Hammonds Mill Farm Estate Hassocks West Sussex BN6 9NB

Class Q Barn Conversions Prior Approval Application (transitional provisions)

Flood Risk Assessment and Drainage Strategy **RESPONSE to MSDC Flood Risk and Drainage Team Comments on FRA (UPDATED)**

19 June 2025

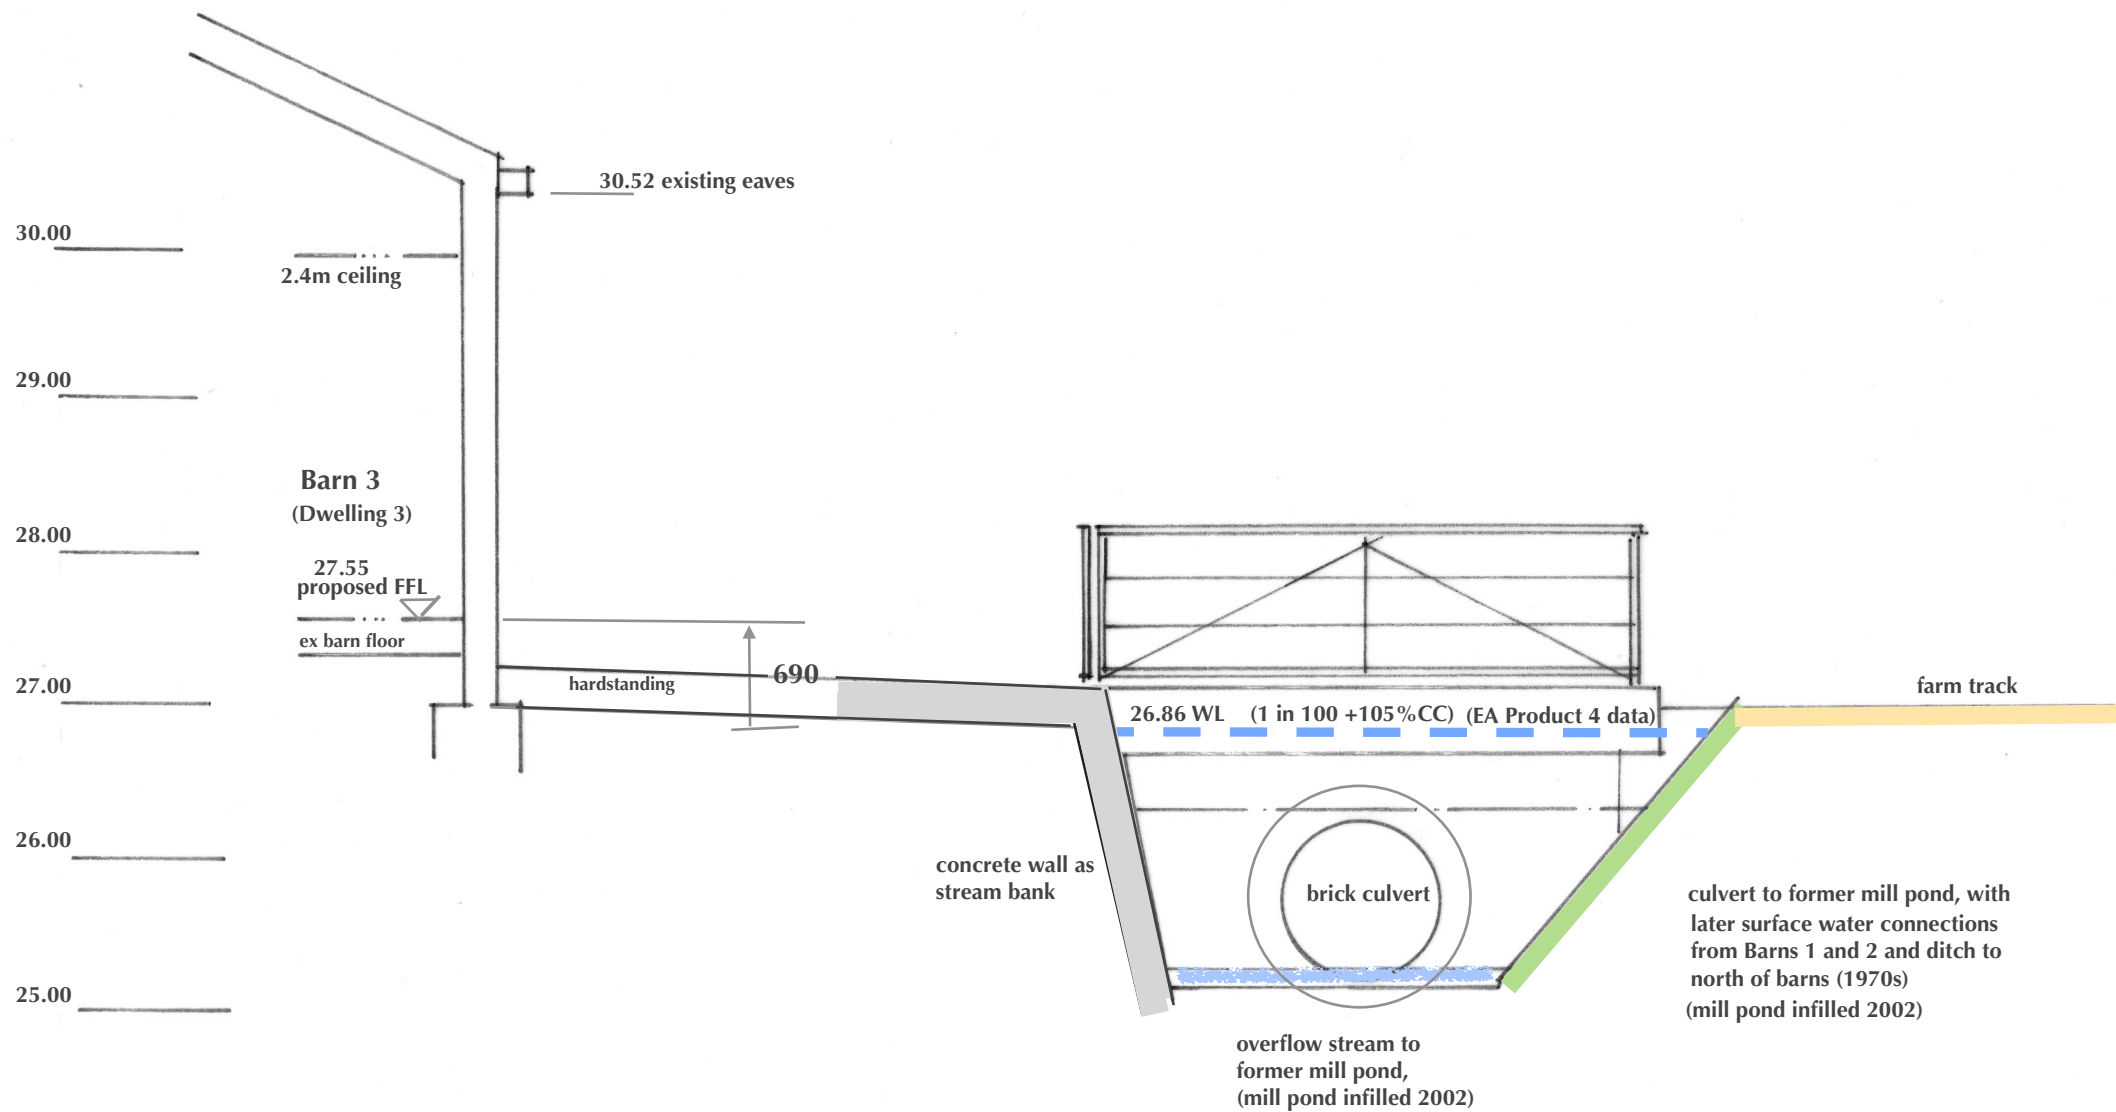
2. In response to the comment that *'the south east corner of Barn 3 (Dwelling 3) abuts Flood Zone 3 and is at high fluvial flood risk'....* the EA Product 4 data set, worst case, (1 in 100 + 105% CC) AED is 26.86. The existing barn floor level is 27.30 but it is uninsulated and needs a new sub base/insulation/floor slab to meet current Building Regulation standards for dwellings. A new floor is a permissible alteration under Class Q rules for conversion of agricultural buildings.
3. The proposed floor level for the conversion with a new floor is 27.55. This is 690 mm above the 1 in 100 + 105 % CC AED.
4. The retained eaves level of Barn 3 (Dwelling 3) is 30.40, which gives comfortably more than a typical 2.4m high internal ceiling height with the proposed floor level.

5. The access point to Dwelling 3 is on the north elevation, via the farmyard where the approach level is 27.40, 540mm above the 1 in 100 + 105% CC AED which results in a B Regs standard, permanent short access ramp to be provided for level access from the farmyard to the new floor level.
6. At the southern end of the east elevation the (the corner that abuts Flood Zone 3 levels) the concrete hardstanding level is 27.35. At the southern elevation existing ground levels vary between 27.12 and 26.96. Locally positioned steps and ramp are proposed to access the dwellings outside amenity area.

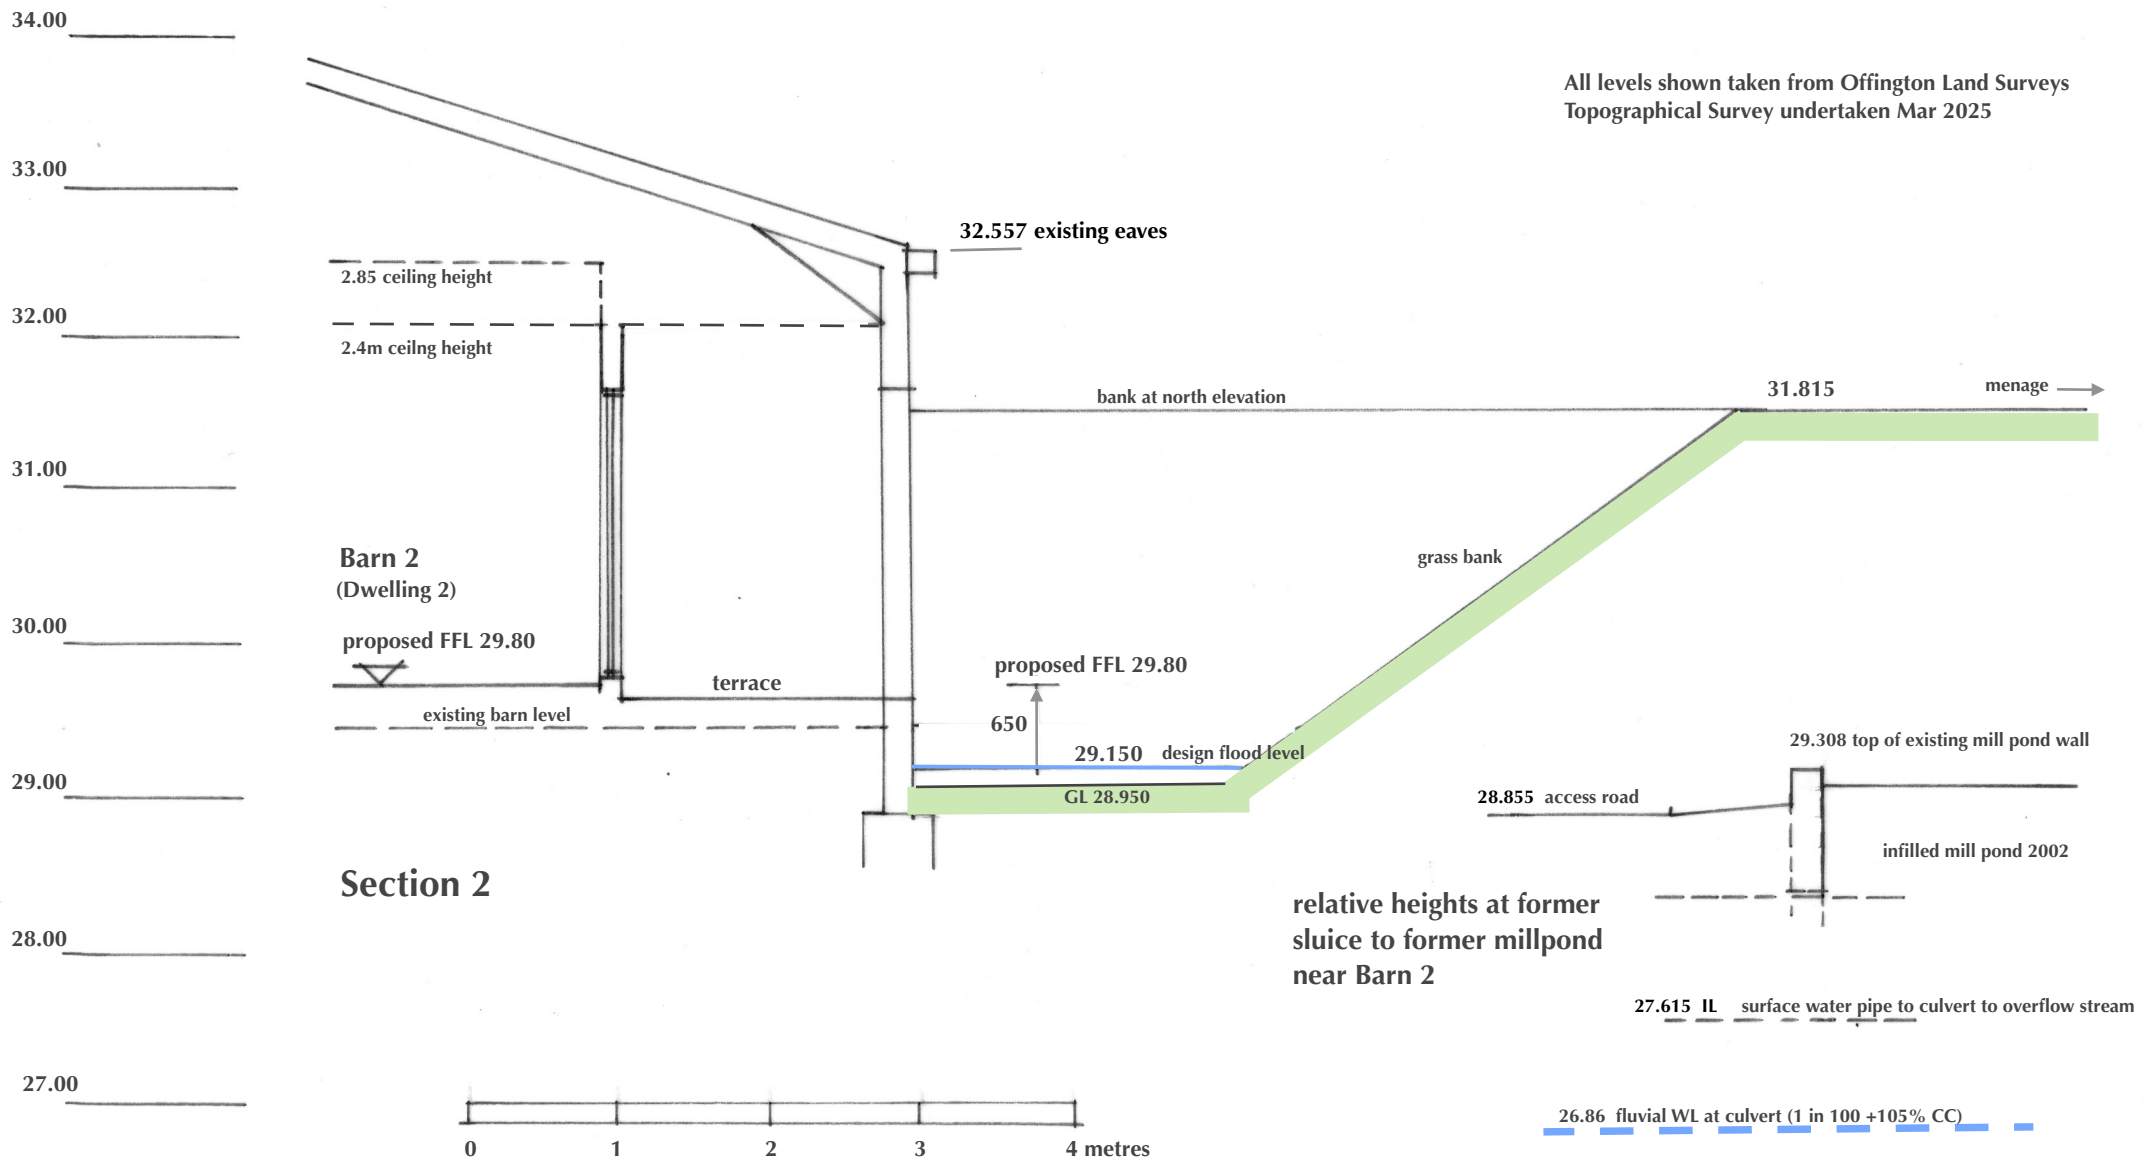
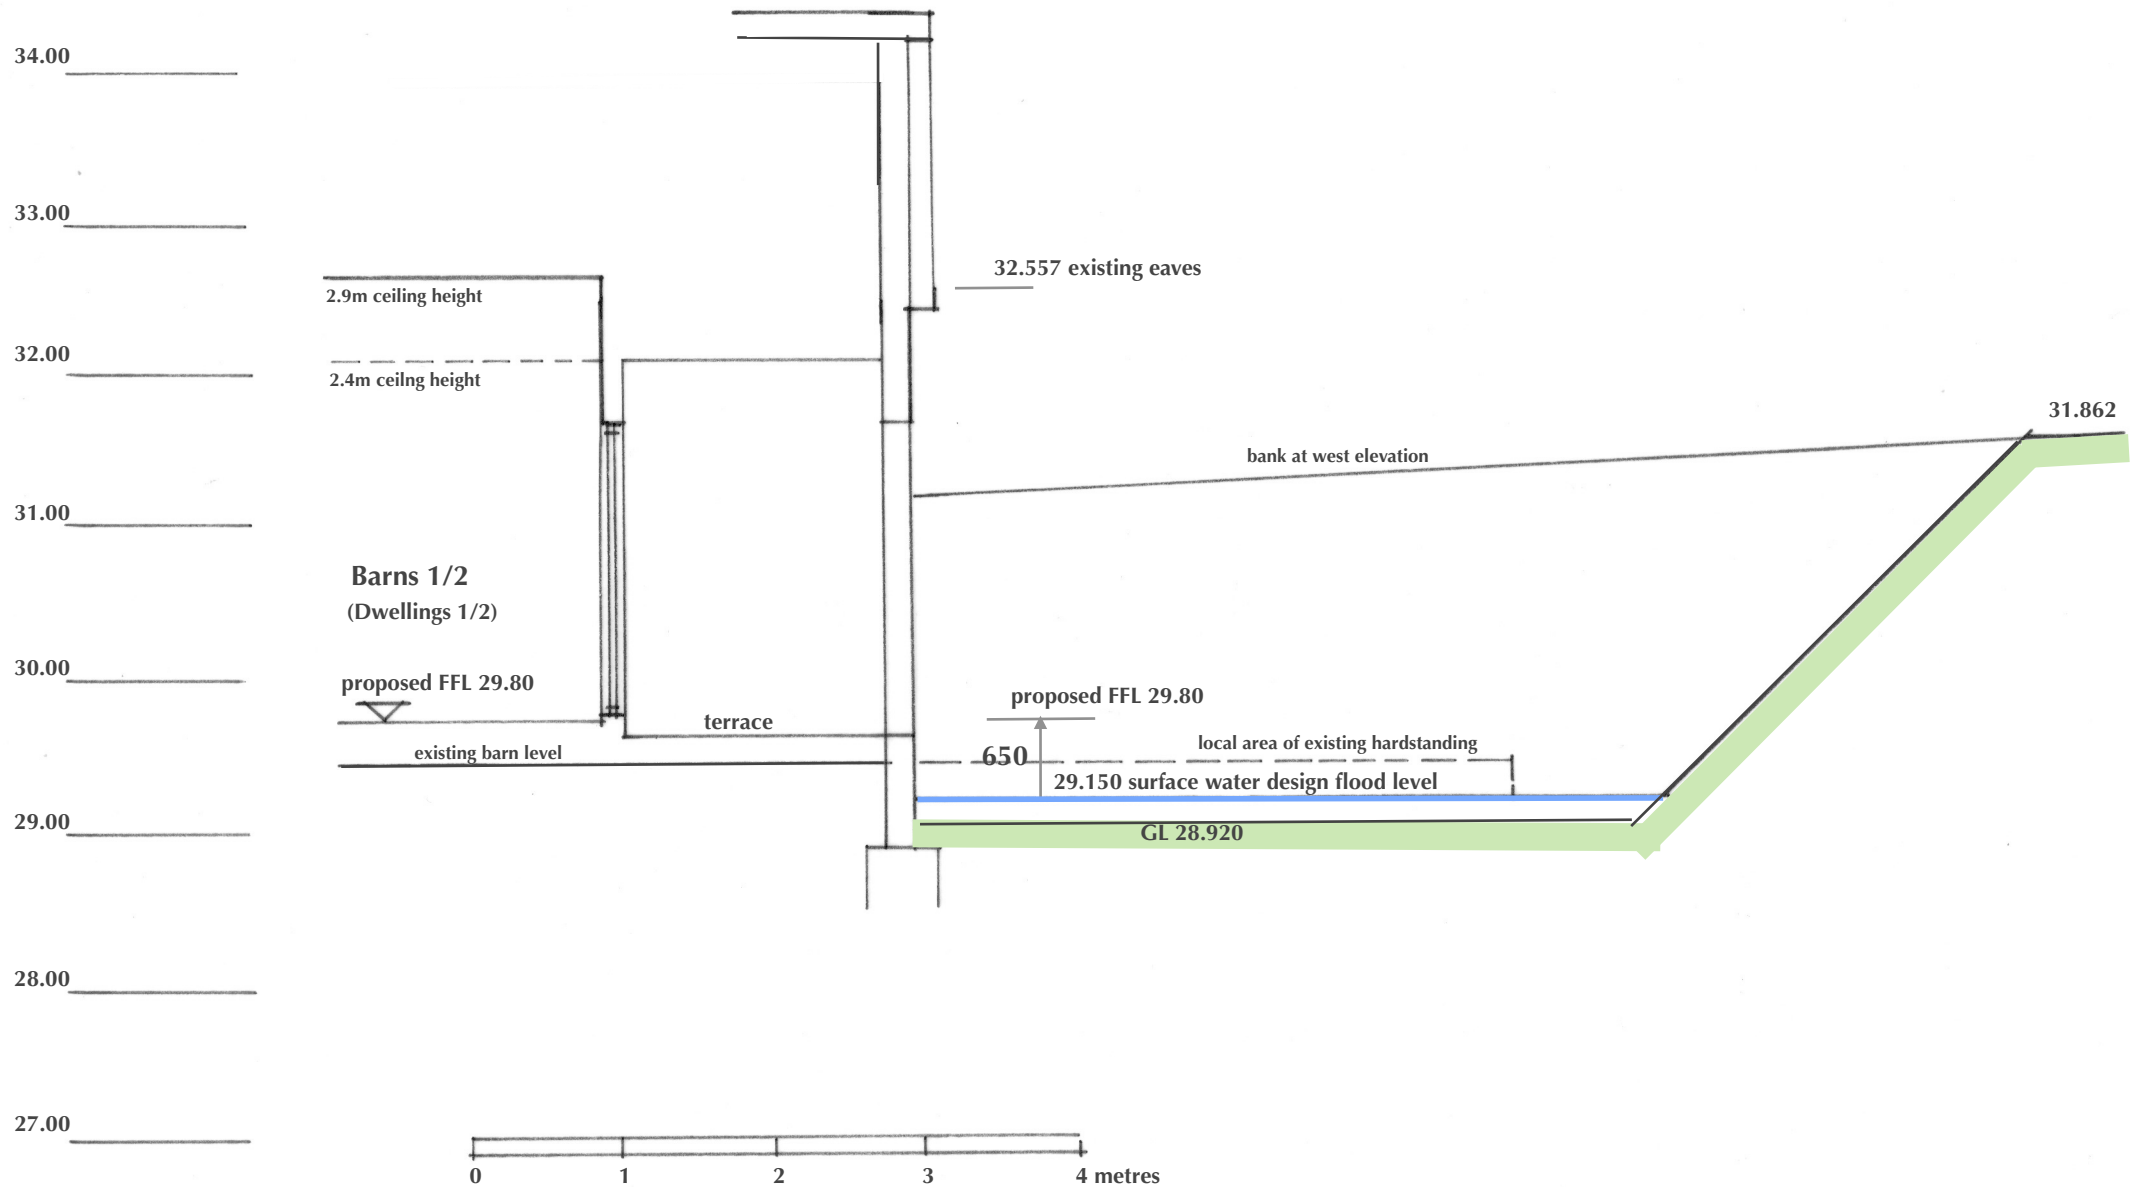
7. In response to the comment that '*Barns 1 and 2 are at medium risk of surface water flooding in the climate change range 2040-2060*', the proposed finished floor levels of Dwellings 1 and 2, at 29.80, gives a 650mm freeboard above the design flood level (1 in a 100 + CC) which meets the EA Standing Advice that MSDC also applies to residential proposals.

8. The existing barn floor levels vary between 29.30 and 28.95 but are uninsulated and need a new sub base/insulation/floor slab to meet current Building Regulation standards for dwellings. A new floor is allowable alteration under Class Q rules for conversion of agricultural buildings. External ground levels at the north and east elevations vary between 29.40 and 29.10.

9. The retained eaves level of Barns 1 and 2 (Dwellings 1 and 2) is 32.57, which gives very comfortably more than a typical 2.4m high internal ceiling height with the proposed floor levels.

10. The access points to Dwellings 1 and 2 are from the south elevation, via the farmyard where the approach level is 29.65, 500mm above the (1 in 100 +CC) design flood level which will allow standard, permanent short access ramps to be provided for level access from the farmyard to the new floor level. This is the high point point of the farmyard which falls to and naturally drains to the south away from the barns.

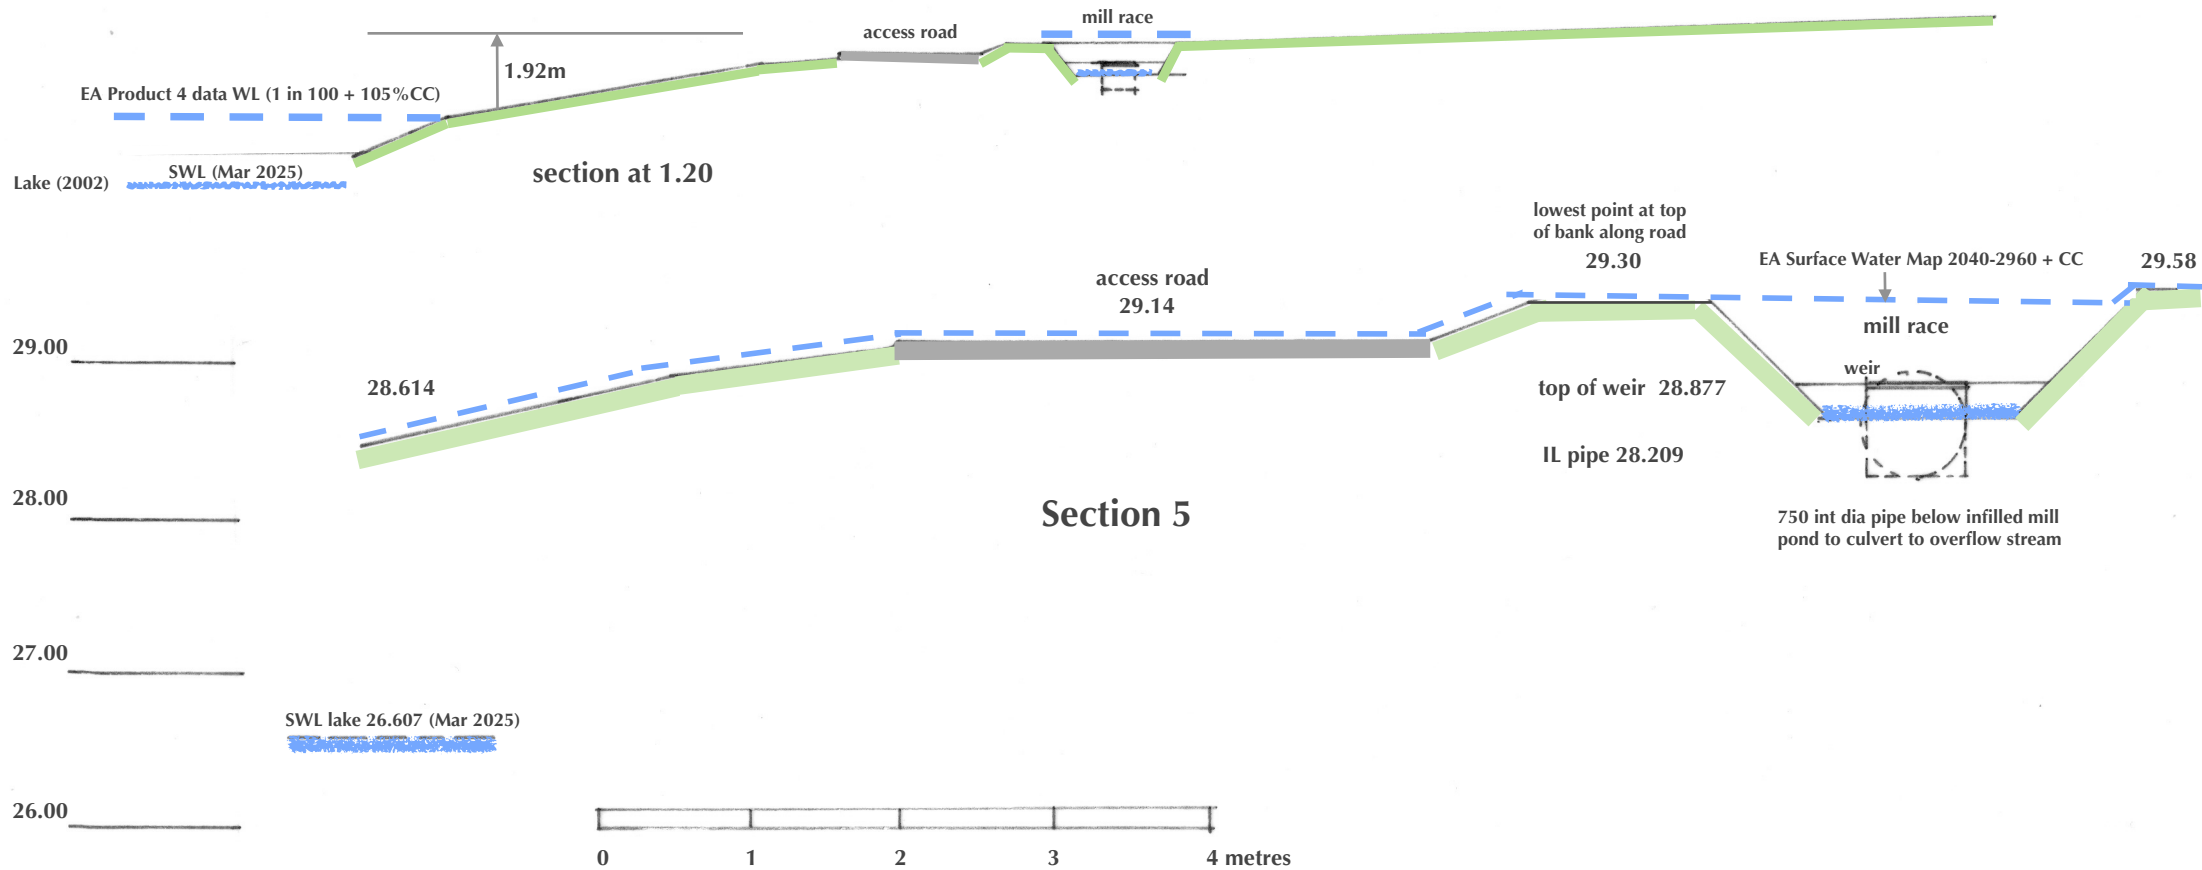
13. In response to the comment that *'the access road/driveway is at high risk from surface water flooding during present day and in the climate change range of 2040-2060'....* levels of banks to the mill race (source of surface water risk including greenfield run off from the north) from the topographical survey undertaken by Offington Land Surveyors in March 2025, show that there are only two local points along the length of the access road/driveway where the parallel southern bank to the mill race is at or below the surface water design flood level.
14. It should be noted that the RoFSW mapping released by the EA in early 2025 is based on 2m square grids, which cover somewhat more than the plan width of the banks to the mill race, which accounts for the flood risk extent to appear to cover further parts of the

15. On the southern side of the access road/driveway, which has a cross fall towards that side and no road kerbs or raised edgings, the grass 'verges' and banks fall at good gradient towards the lake (the western end) and towards the Herrings Stream (the eastern end). The 1 in 100 + 105% CC AED for the lake and the Herrings Stream is between 1.72m and 1.92m below the levels of the top of the southern bank of the mill race which is typically 300mm above the access road/driveway level.

16. During an exceedance event any surface water flooding from the mill race over the access road/driveway is likely only to occur at two locations and will drain quickly over the road and down the grass banks to the lake or the Herrings Stream, where even in a 1 in 100 + 105% CC flood event there is a substantially comfortable capacity for the lake and Herrings Stream to absorb any surface water run off from the mill race, over the road, without increasing flood risk elsewhere on the Hammonds Mill estate.
